VISIT TO THE BASALT WASTE  
ISOLATION PROJECT (BWIP)  
HANFORD, WASHINGTON

DIVISION OF WASTE MANAGEMENT  
U.S. NUCLEAR REGULATORY COMMISSION

NOVEMBER 1981

Figure 1

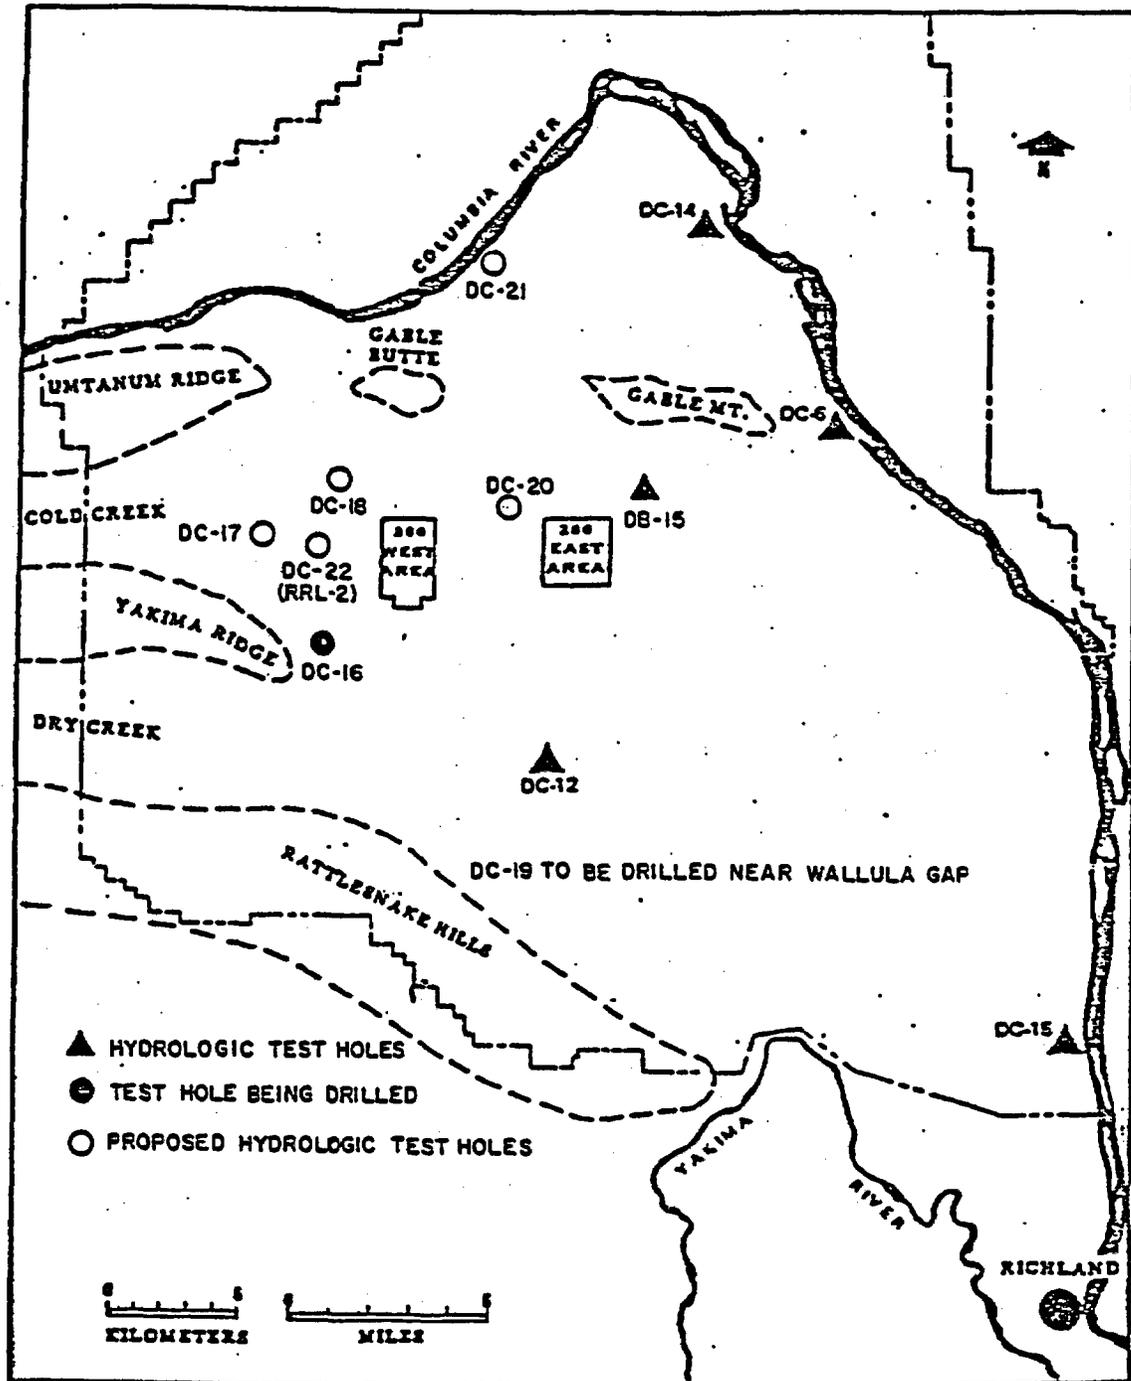
A Reference Repository Location (RRL) has been designated on the northern limb of the Cold Creek syncline in the 200 West area. An Exploratory Shaft (ES) has been sited 300 feet from borehole RRL-2 (Figure 1). Early in 1982, borehole RRL-2 will be cored and tested hydrologically to a depth 500 feet below the repository level. RRL-2 will be redesignated DC-22 when this work commences. DC-22 will act as a pilot hole for the ES, and preshaft testing will be accomplished in DC-22.

Plans for the next five years call for the drilling and testing of six small diameter core holes (Figure 1). Paired hole testing of the Umtanum by low volume pumping is planned in DC-4 and DC-5 and/or DC-7 and DC-8. The distances between these pairs of holes is less than 150 feet, and the holes are more than 5 miles from the RRL. While the data from the planned paired hole testing will be helpful, the value will be limited for several reasons. (1) Because of the close spacing of hole pairs (less than 150 feet) only a limited volume of rock will be tested. (2) Casing presently in the holes restricts testing to the Grande Ronde; no properties of higher units will be measured. (3) In view of the distance between the holes and the RRL, and the expectable lateral variation within the Umtanum, it is questionable whether the test values for the Umtanum can be applied to the RRL.

Figure 2

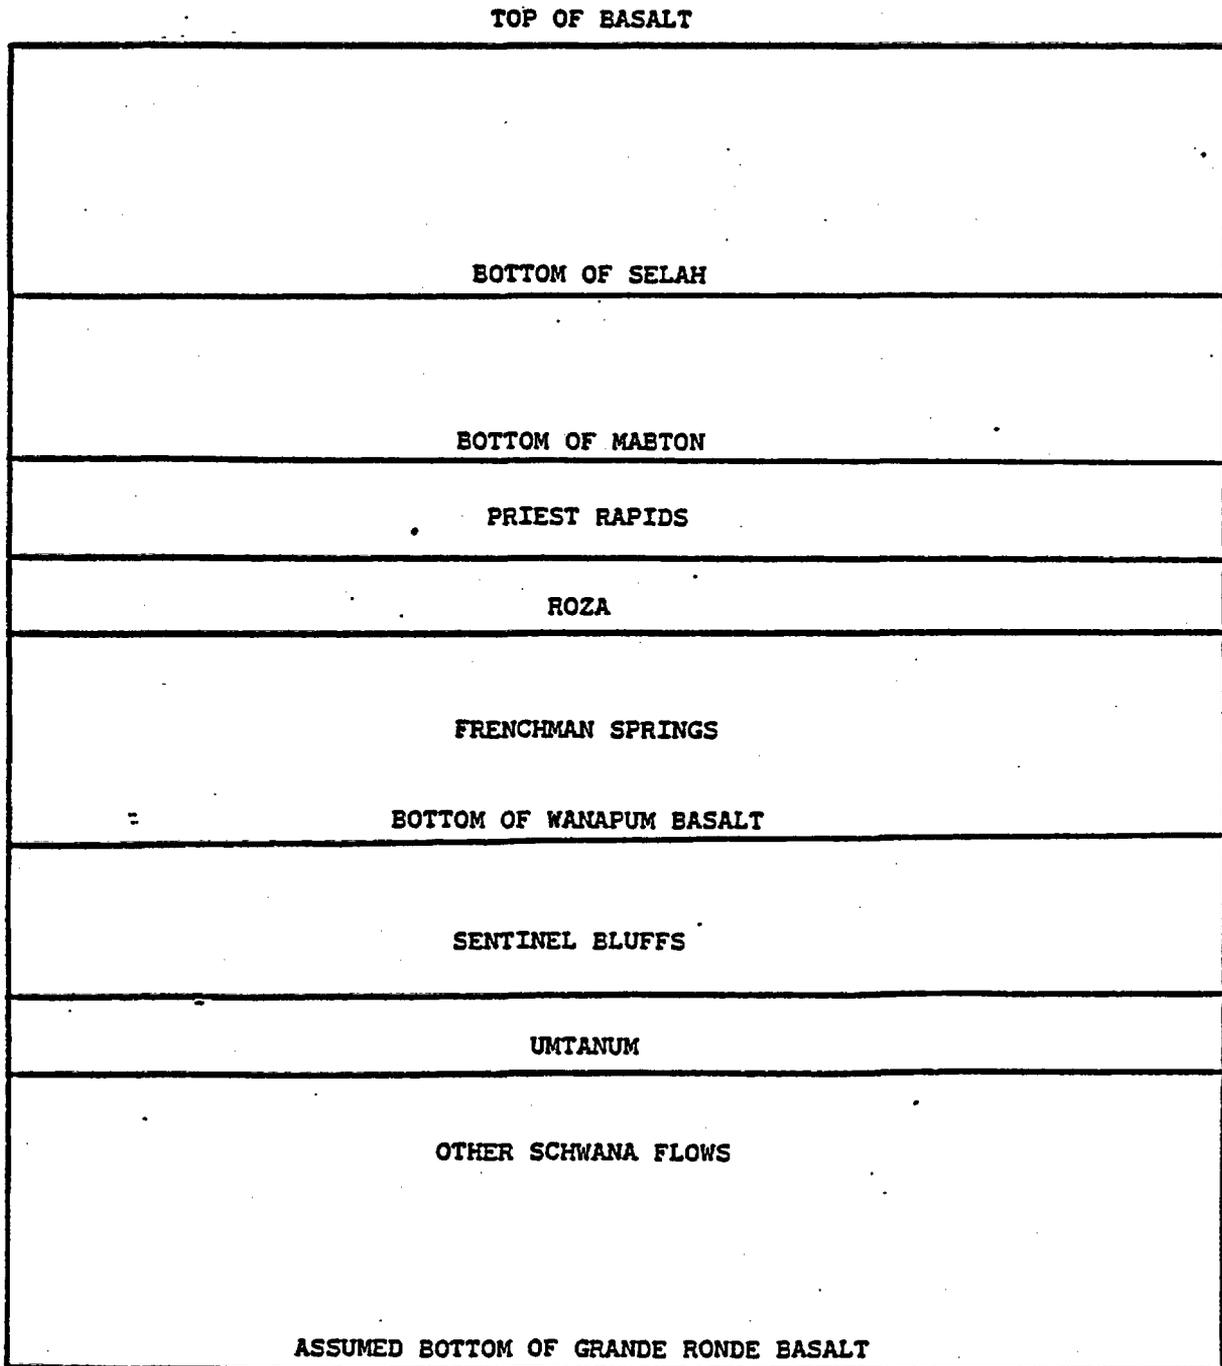
Conclusions drawn by RHO from the study are: (1) flow from the Saddle Mountains formation and possibly from the upper Wanapum formation discharges to the Columbia and Snake Rivers; (2) lower formations may discharge at Wallula Gap or beyond, with no apparent connection with the Columbia River outside of Wallula Gap (This may be due solely to choice of boundary conditions); and (3) the composited layering scheme is not conservative and more layers are needed to accurately calculate travel times. Figure 2 shows the layering scheme proposed for the multilayer model.

(FIGURE 1)

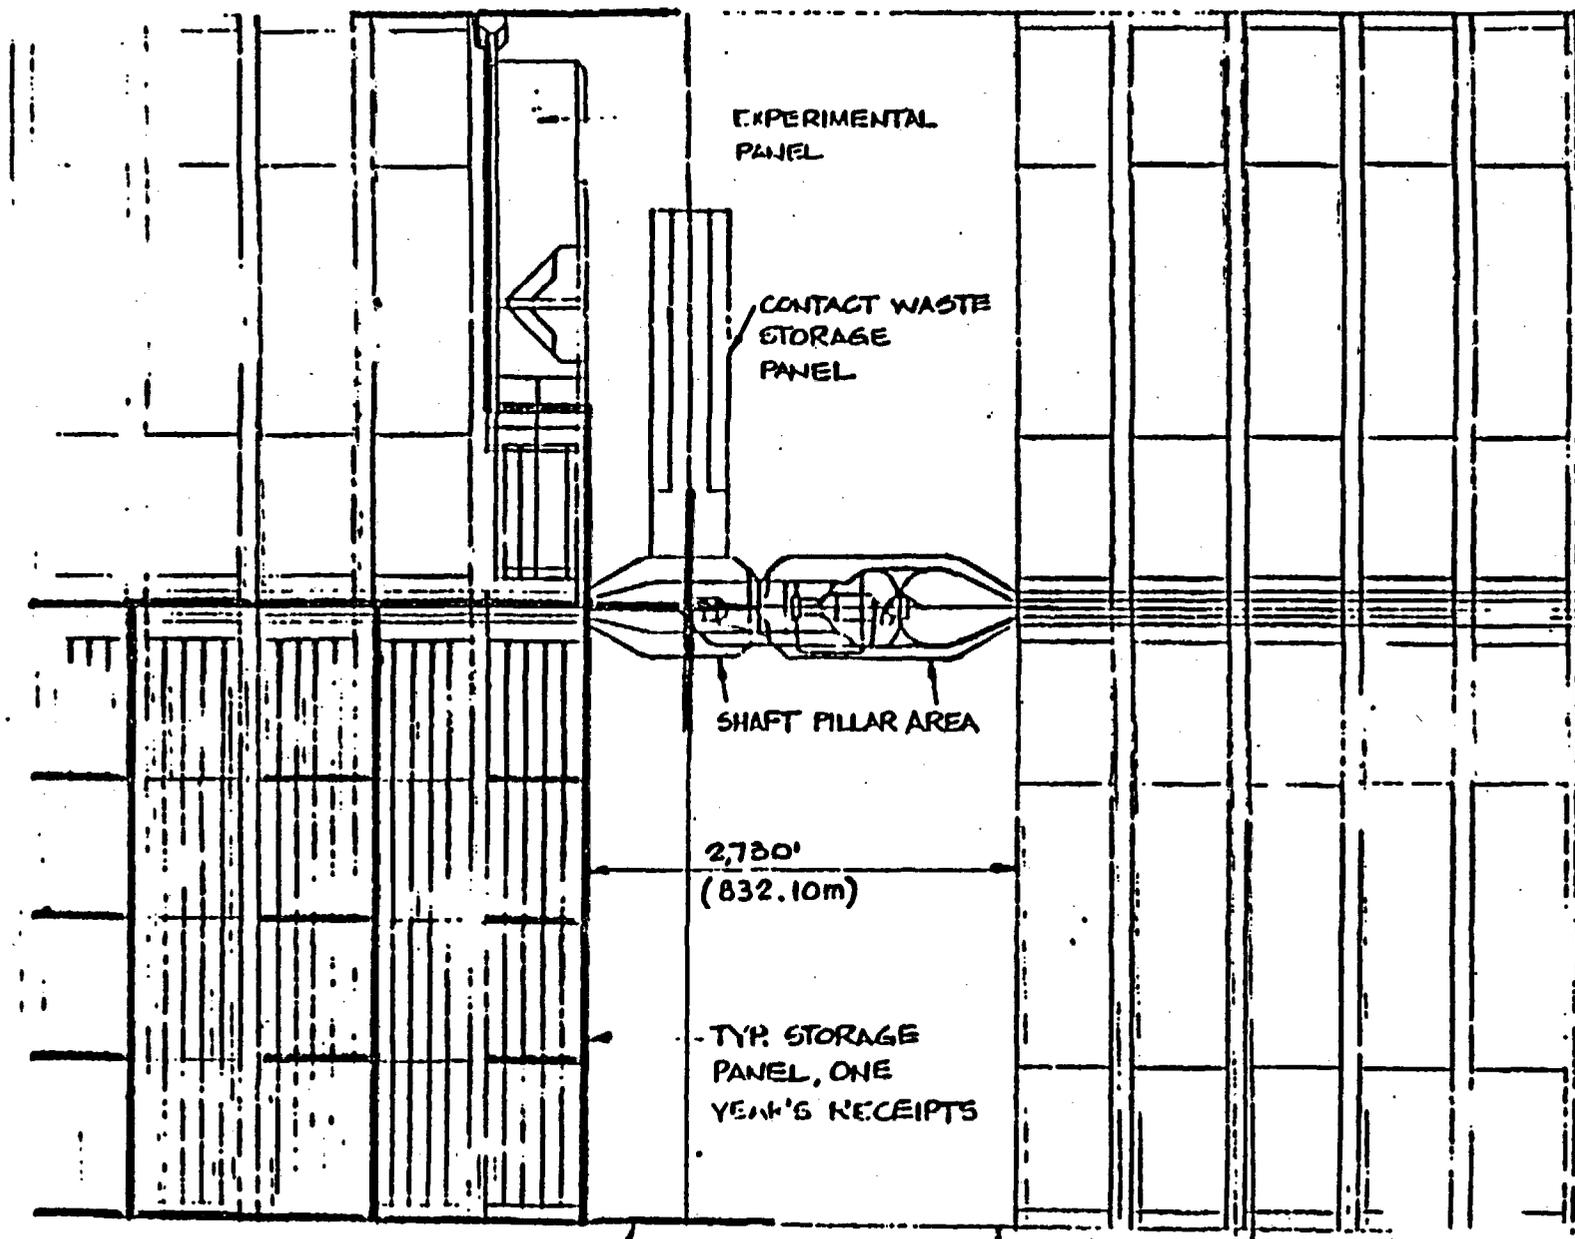
The proposed repository layout incorporates a substantial shaft pillar between two main storage areas. This pillar, 7800'x2730', will contain the five main repository shafts, the contact waste storage panel, and the ESTF (Figure 1). The exact location of the ESTF within the shaft pillar has not been specified. It is our opinion that this is the correct decision, and that the shaft pillar is sufficiently large to contain the ESTF without jeopardizing the performance of the repository. Information obtained from this initial entry into the repository horizon will provide a base with which to compare and evaluate the results of ongoing exploration drilling and development activities, which are an essential part of repository design verification.
